**ENFIELD INLAND WETLAND & WATERCOURSES AGENCY**

**TUESDAY, MARCH 16, 2010**

**PUBLIC HEARING**  
**IW 534 – Enfield Properties**

**To:** Enfield Inland Wetlands and Watercourses Agency  
**From:** Katie Bednaz, Assistant Town Planner/Wetlands Agent  
**CC:**  
**Date:** March 11, 2010  
**Re:** Agent Review for IW# 534 – South Road (2)

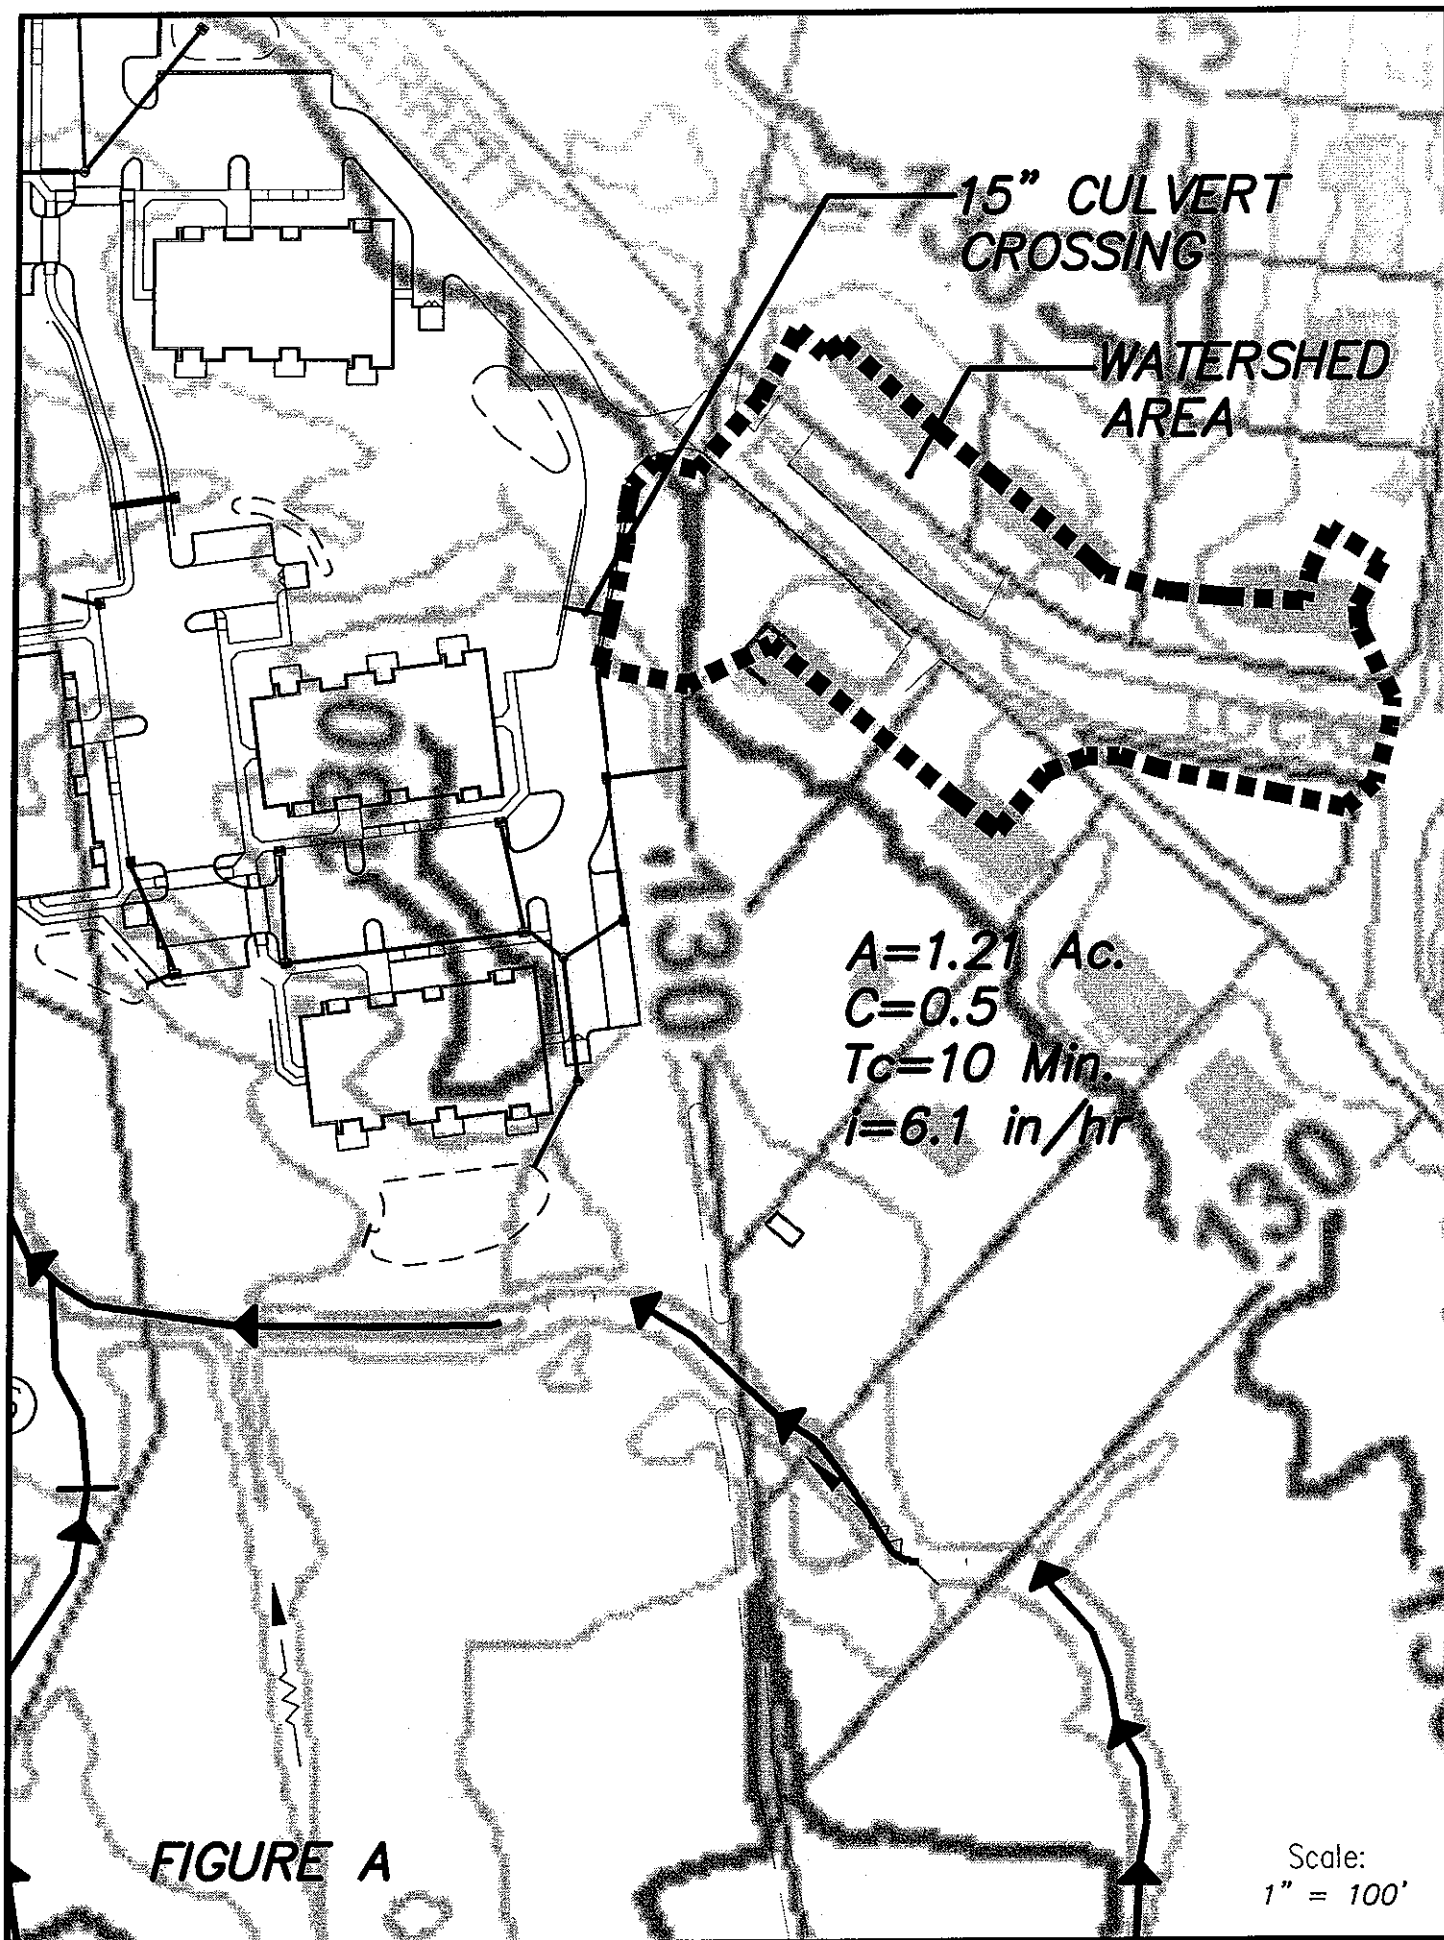
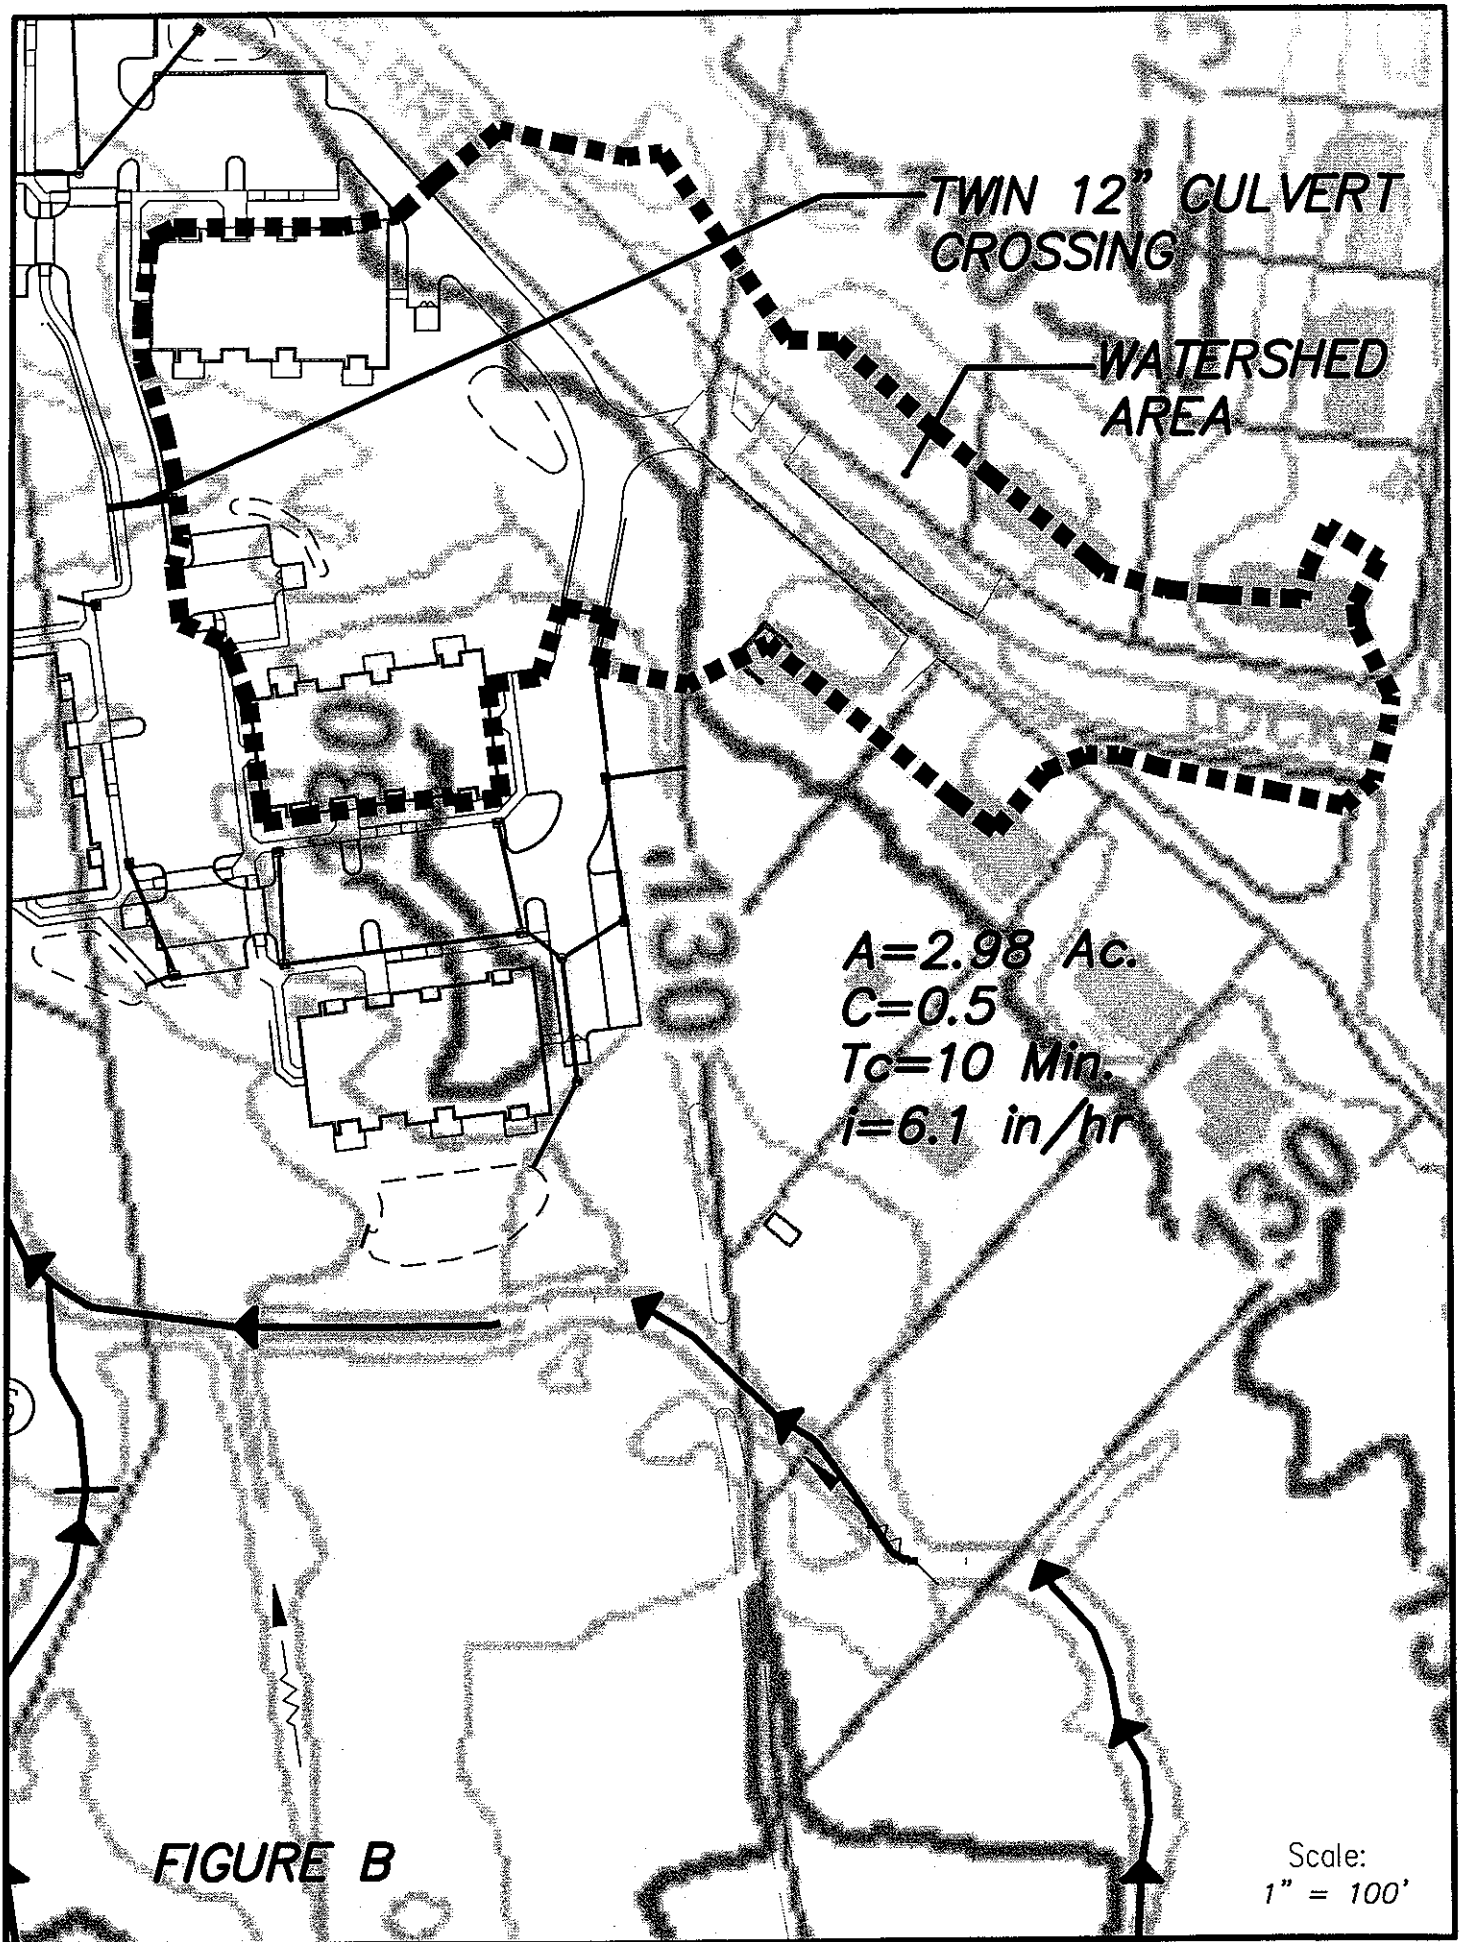
- G. With the newly-proposed phasing plan, a more detailed phased plan set should be submitted which will indicate how the drainage system will be installed through the proposed phase lines and how the erosion controls and grading will be installed as these phases could possibly stand alone for a significant time. Specific detail should be shown at the phase lines which cut through the proposed improvements and the roadway stubs.

**A more detailed phase plan for Phase 1 has been generated and is attached as Sheet PH-2. The Phase 1 plan depicts the limits of Phase 1 construction superimposed over the overall construction plan. The proposed grading, erosion control measures, utilities, and storm drainage improvements for Phase 1 are depicted on this plan. During Phase 1, Water Quality Basin #9 (WQB #9) and associated storm drainage systems that drain into WQB #9 will be constructed. Both the main drive and emergency-access drive from south Road to the residential portion will be constructed. The area between WQB #9 and the future commercial building will be rough graded and runoff directed to the catch basins of the storm drain systems that discharges into WQB #9. Portions of the main drive will be promote sheet flow through the future parking areas to the basins.**
